## **REMARKS/ARGUMENTS**

This Amendment is responsive to the Office action dated February 23, 2005, setting forth a shortened three month statutory period for reply expiring on May 23, 2005. A petition for a three month extension of time and associated fee are filed herewith, extending the period for response up to and including August 23, 2005.

Appl. No. 10/796,859  
Amendment dated August 23, 2005  
Reply to Office Action of February 23, 2005

FIG. 1

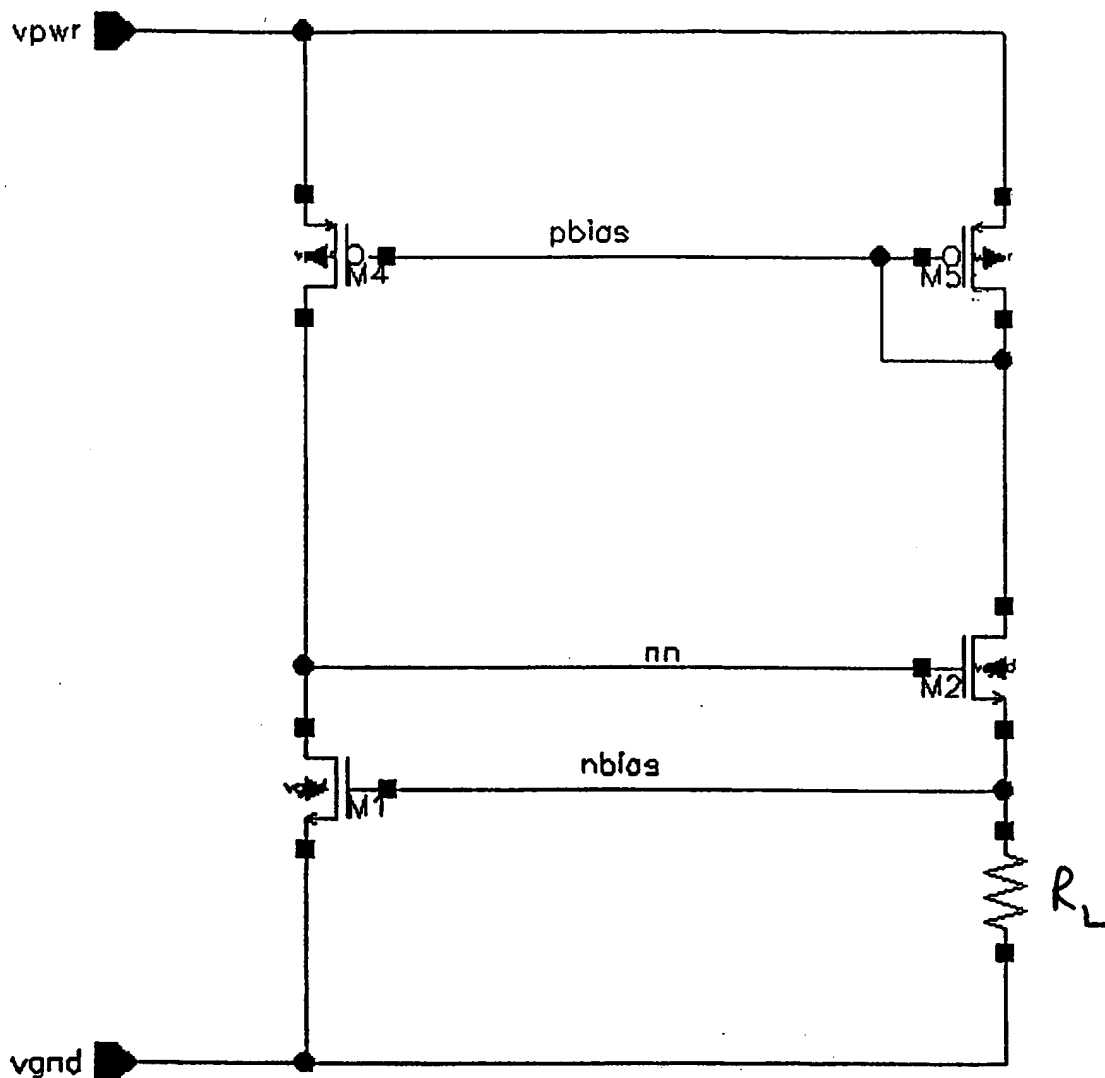
The Examiner required that Fig. 1 be designated with a legend "prior art." Fig. 1 has been labeled "PRIOR ART" on a replacement sheet that is attached hereto. Accordingly, this objection to the drawing should be withdrawn.

The attached sheet of drawings includes changes to Fig. 1. This sheet, which includes Fig. 1, replaces the original sheet including Fig. 1. In Fig. 1, the legend "PRIOR ART" has been added.

PRIOR ART  
LEGEND  
ADDED
